Pre 90% Far Site CF update

Mucking drift update

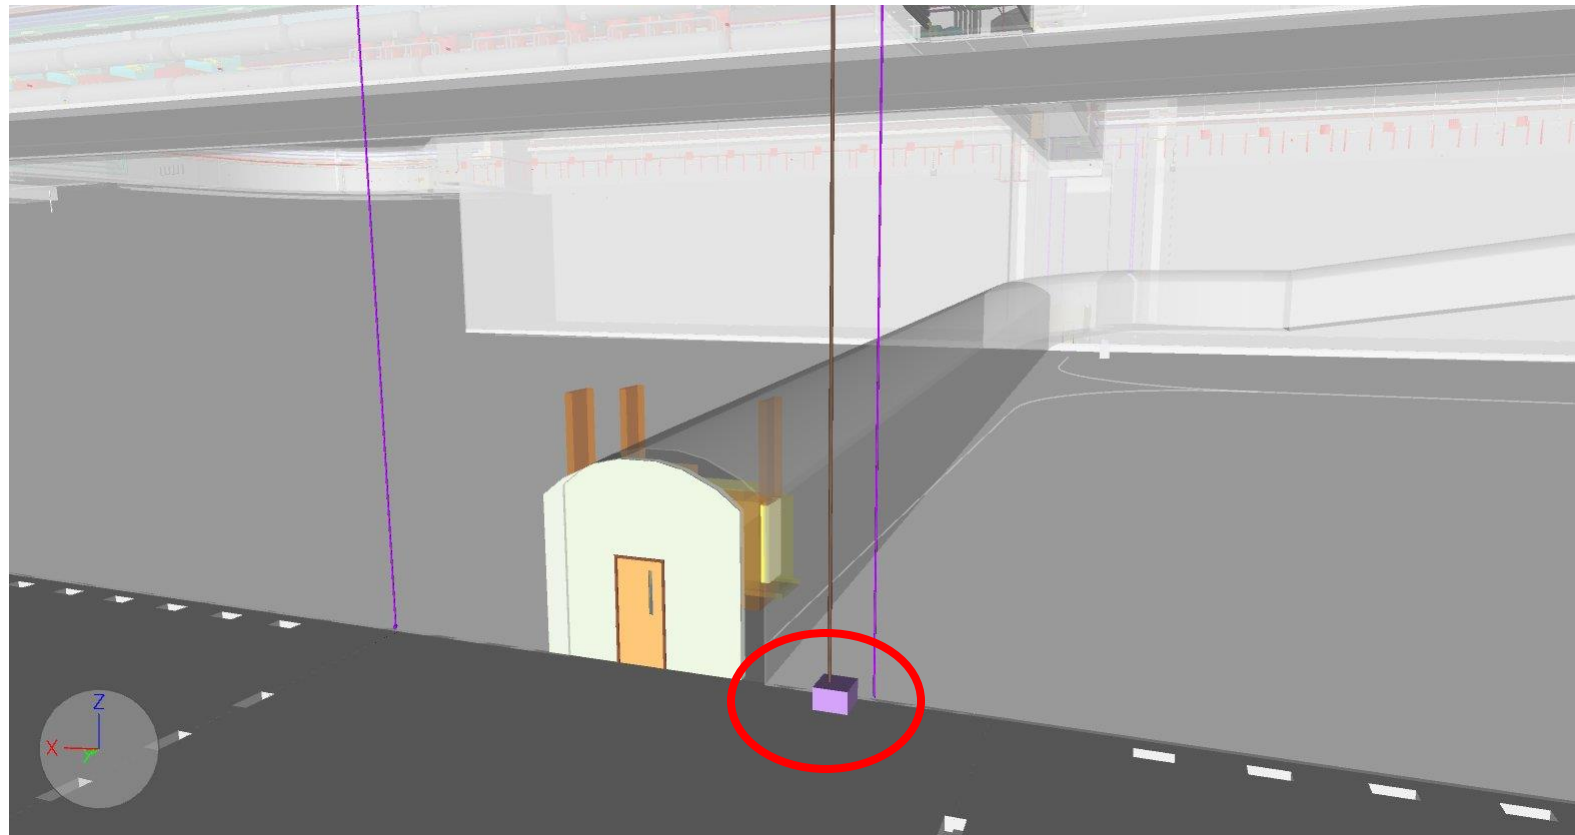
- The mucking drifts have been moved inline with the N-S drifts. This eliminates interference with the stairs, cryo pumps and cryostat warm structures. It also leaves the possibility to access these drifts during later phases of construction, if deemed necessary.

- The sumps to capture and remove water from the 4910 level were shifted due to the relocation of the mucking drifts.

Electrical panels in entrance of mucking drifts

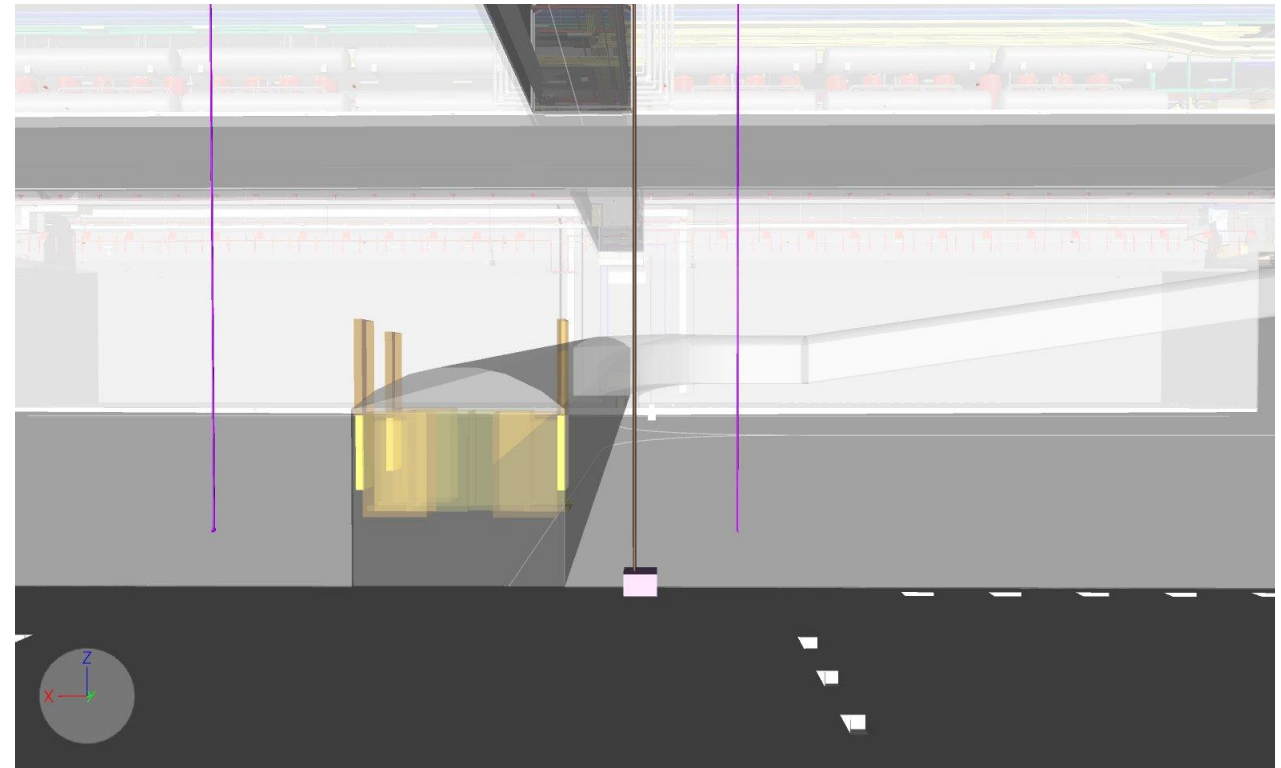
- Previously there were electrical panels populating the walls of the N/S drifts where cryogenics pipes and detector cabling needed to go. These panels will be relocated into a short (4 to 5 m) portion of the mucking drifts.
- Details needed –
 - exactly which panels will be relocated, outfitting required shotcrete, concrete inverts, sprinklers, lighting

East entrance of CUC

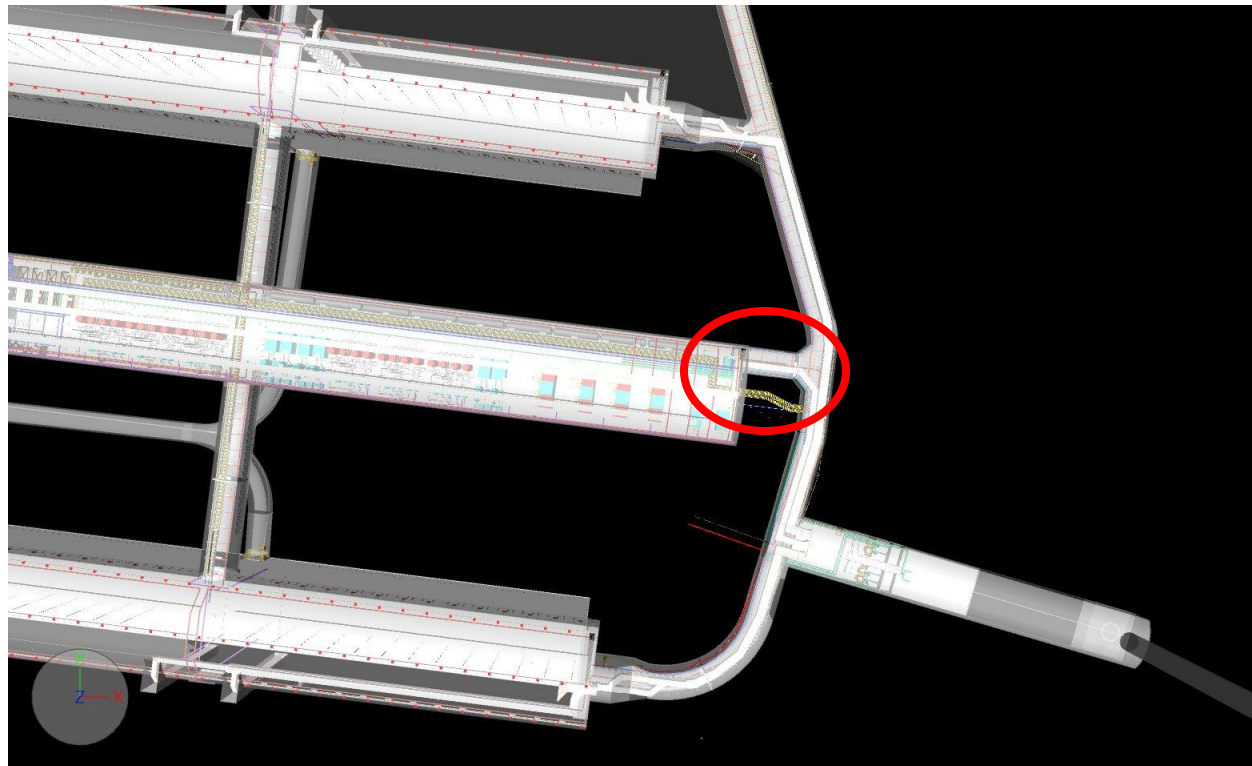
- Previously the east entrance of the CUC was centered, unlike the west entrances that was skewed to the north. This created some unnecessary complications for service routing and material movement.

East CUC

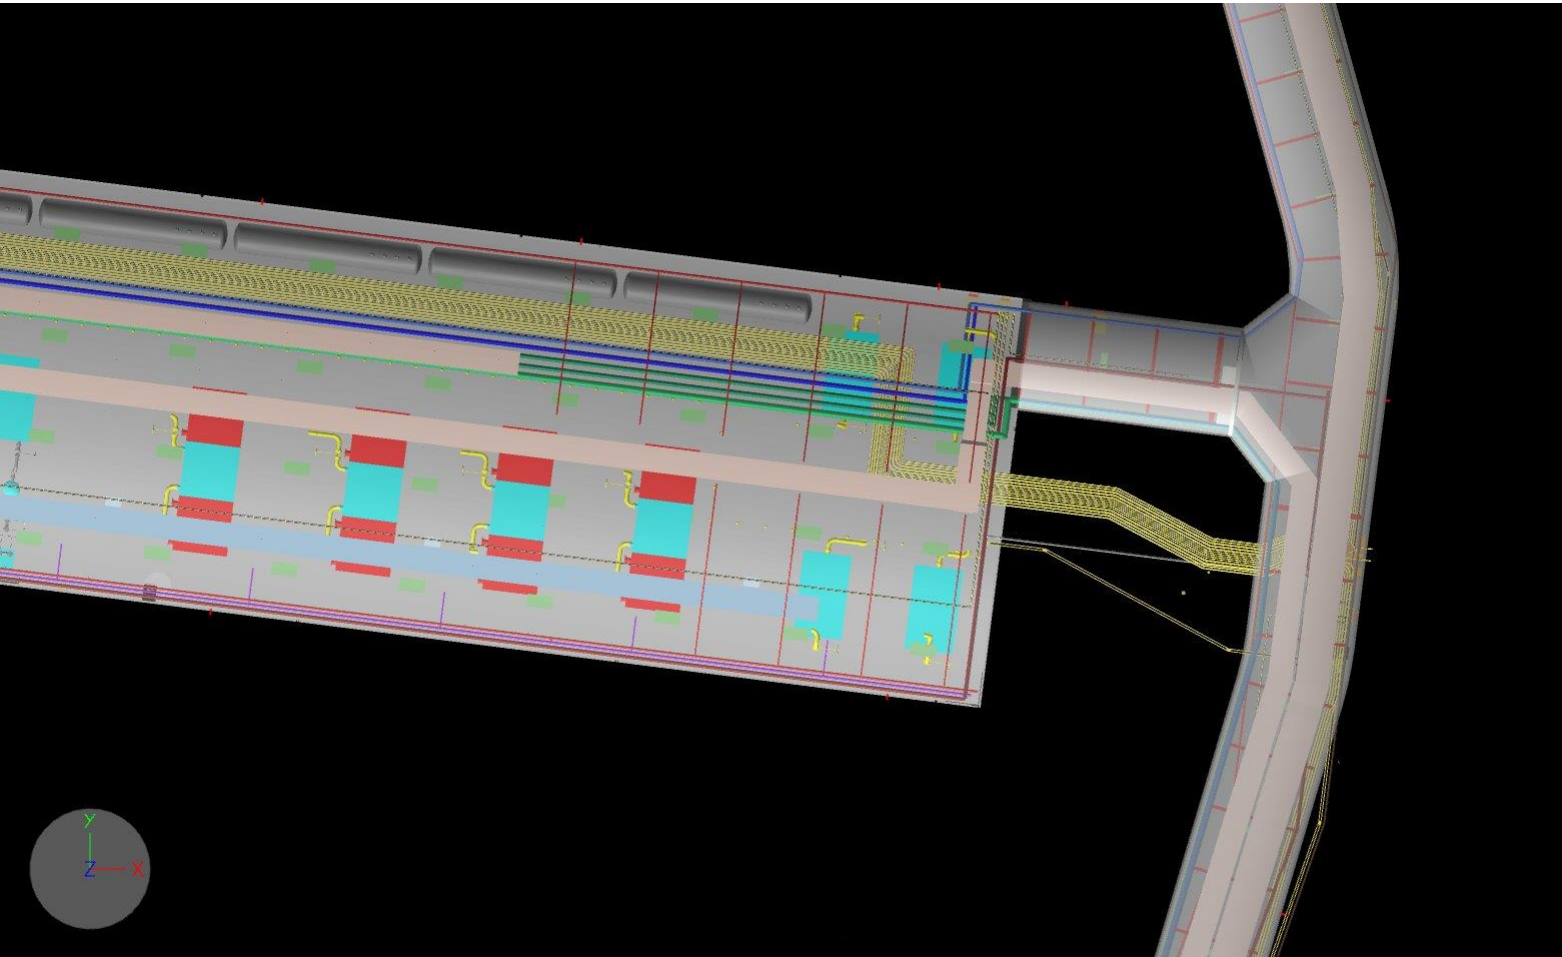
- Work still to do from CF in process
 - Reroute all of the cooling pipes from spray chamber to CUC for chillers
 - Reroute ducting and electrical services

CUC east

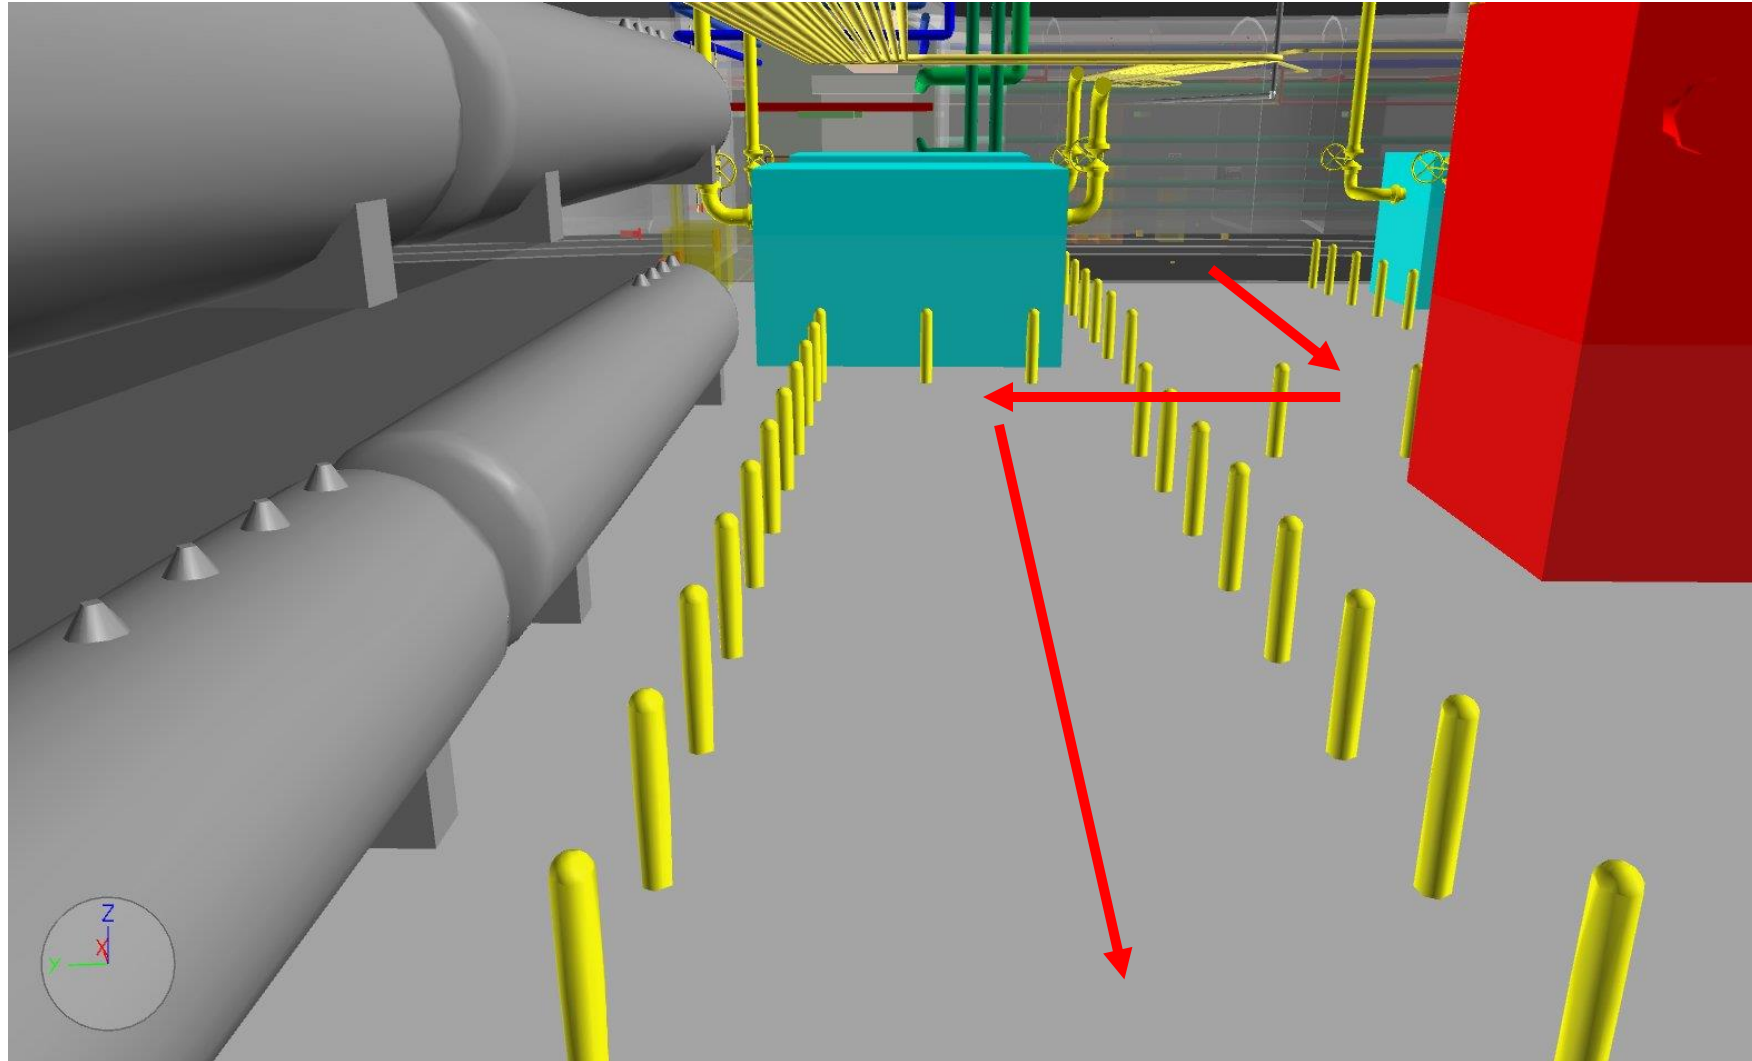
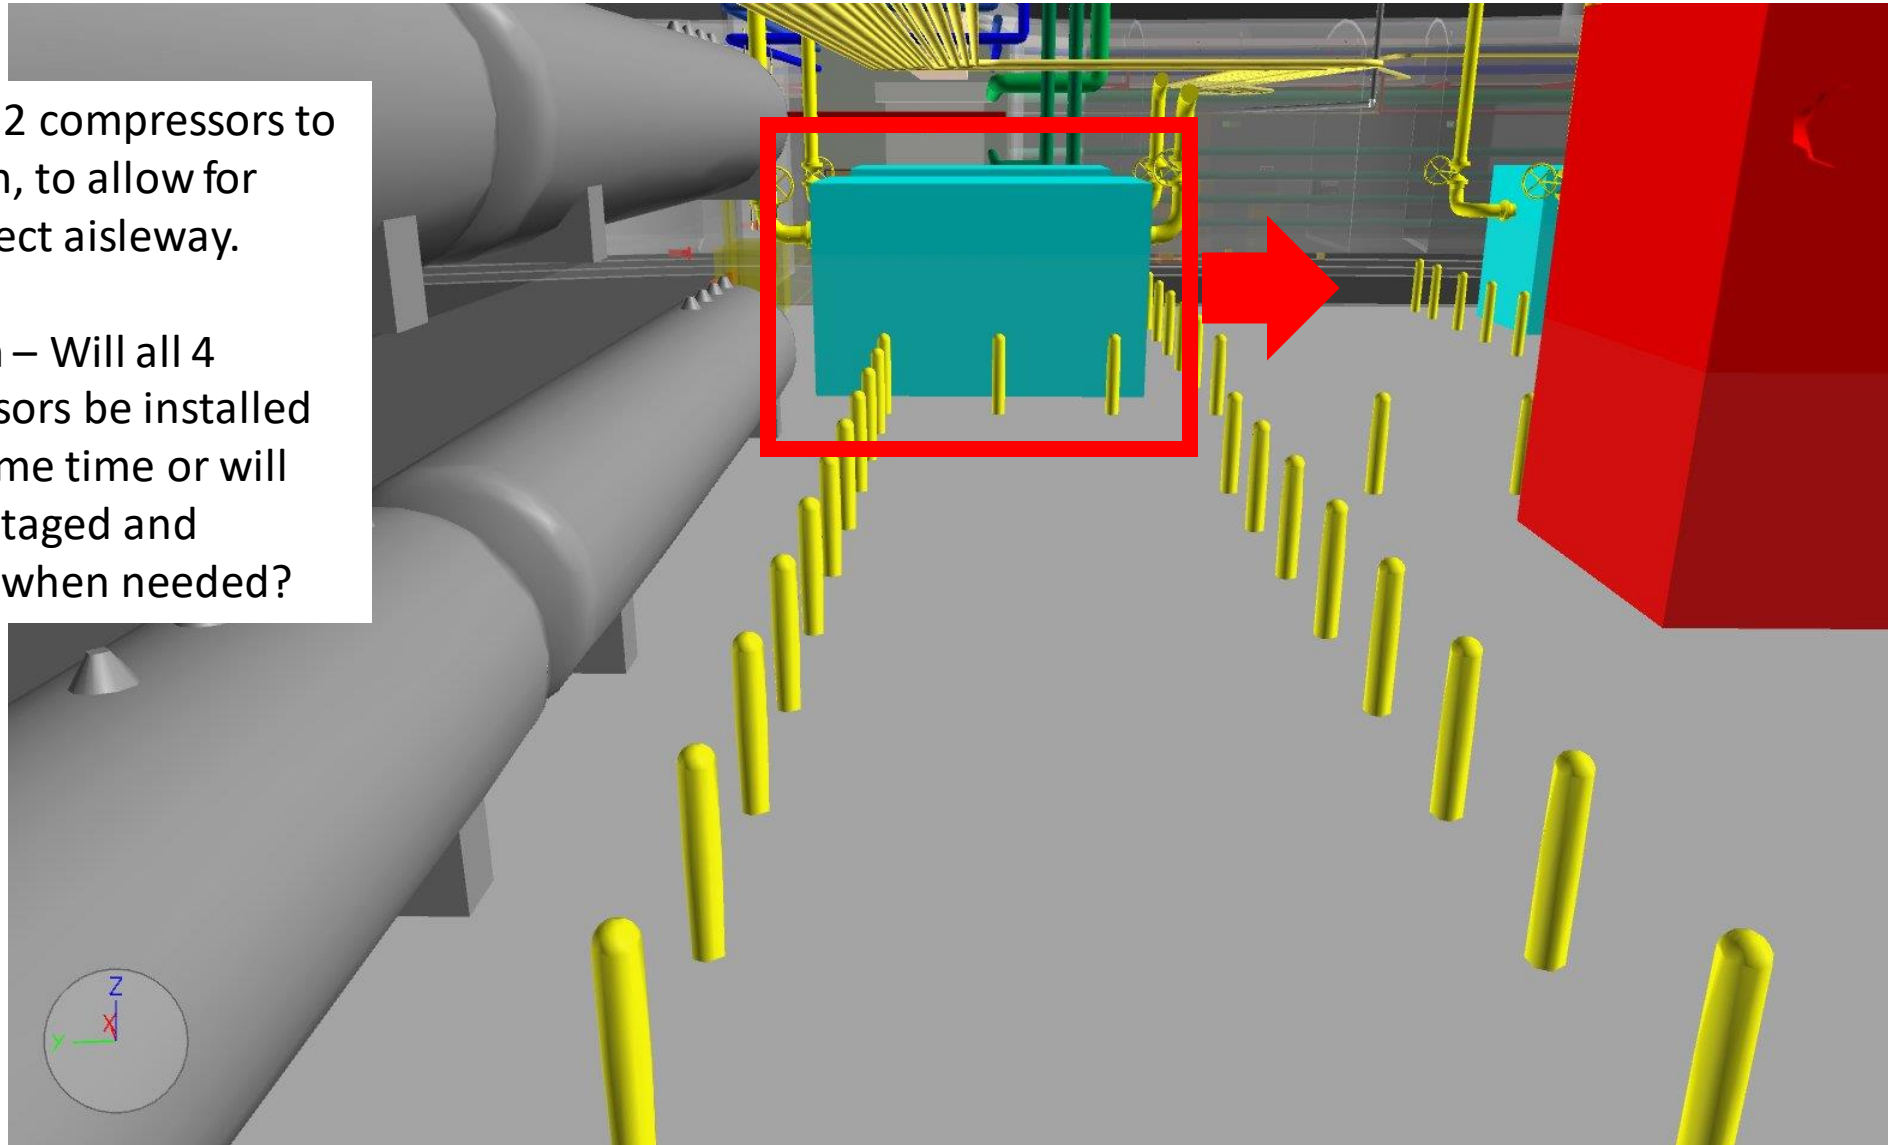
Relocate 2 compressors to the south, to allow for more direct aisleway.

Question – Will all 4 compressors be installed at the same time or will they be staged and installed when needed?

Bollards

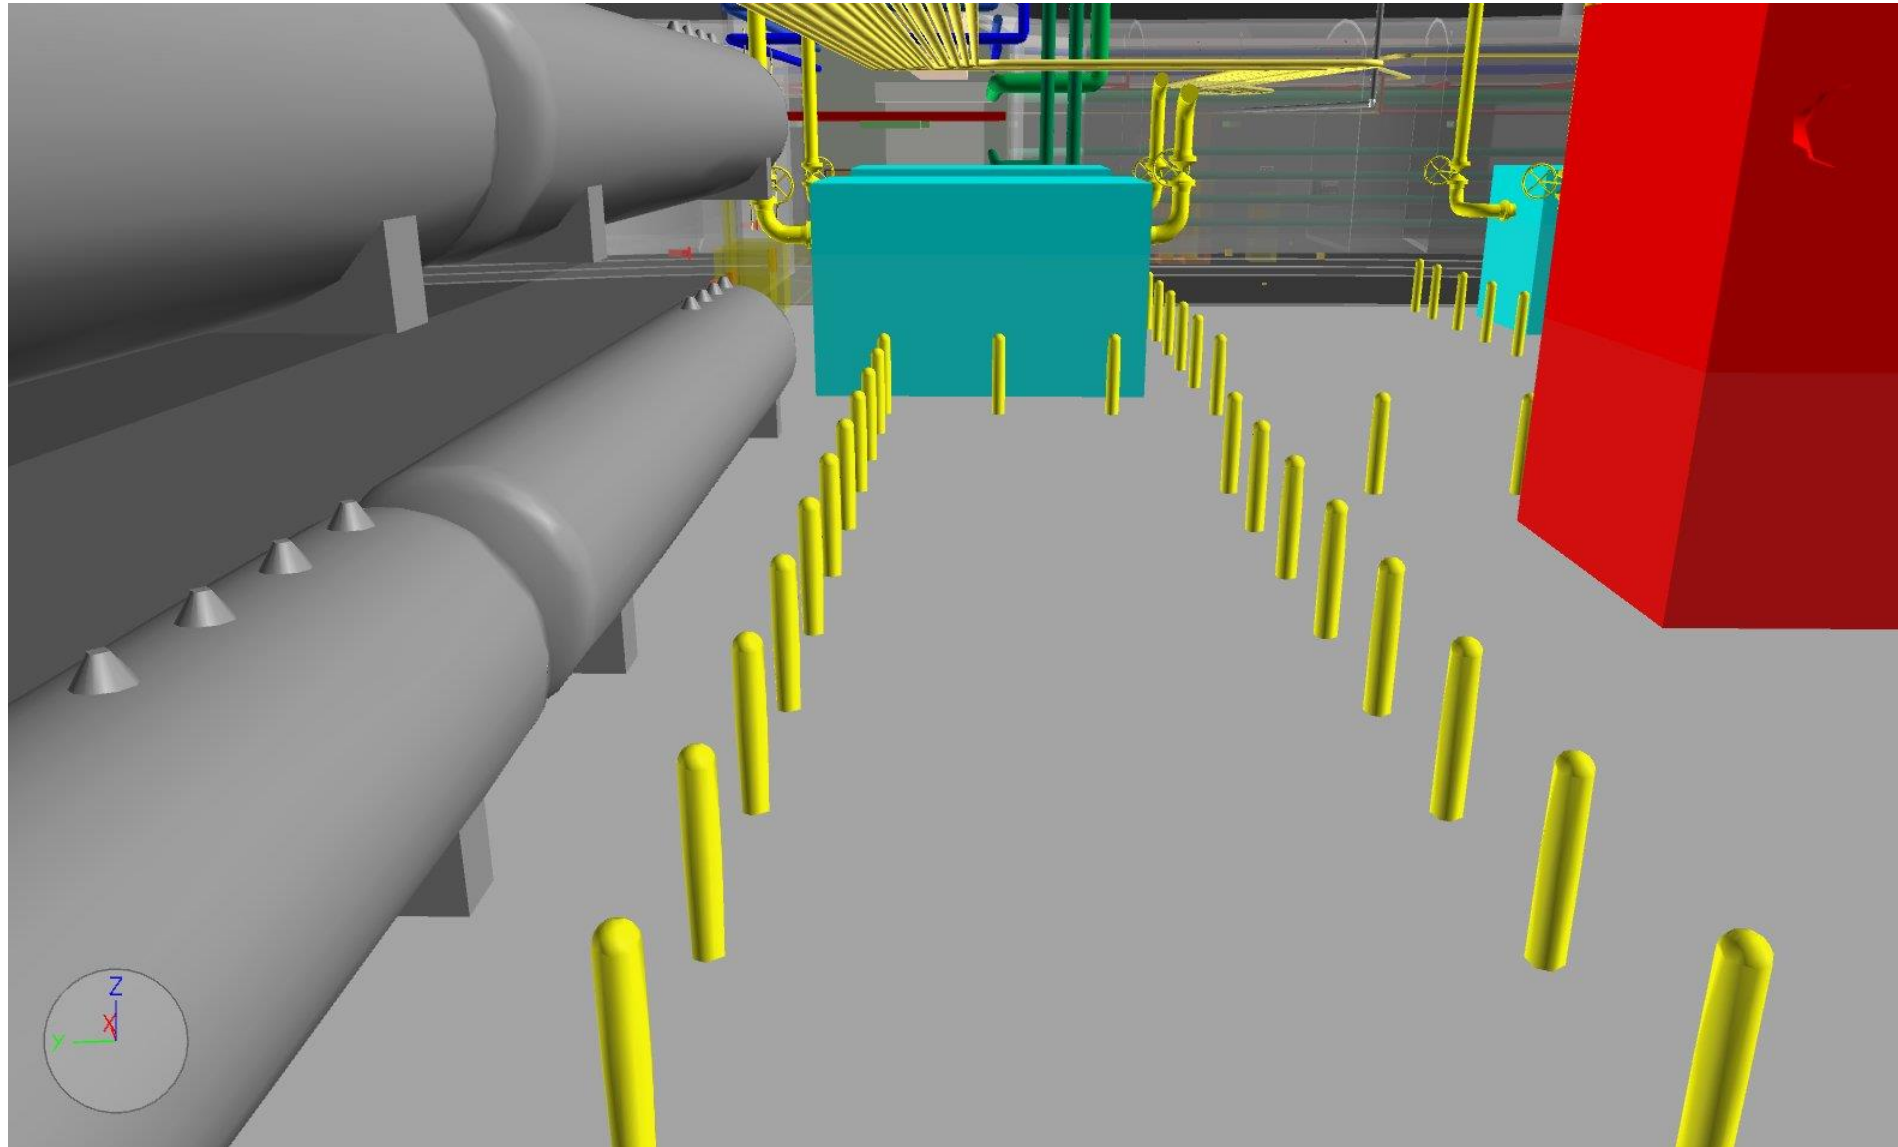
- Also, ARUP asked us to revisit the requirements for the bollards and CF is recommending that the installation is removed from their scope to allow for changes as the designs of the CUC equipment matures. This would move to a post CF requirement.
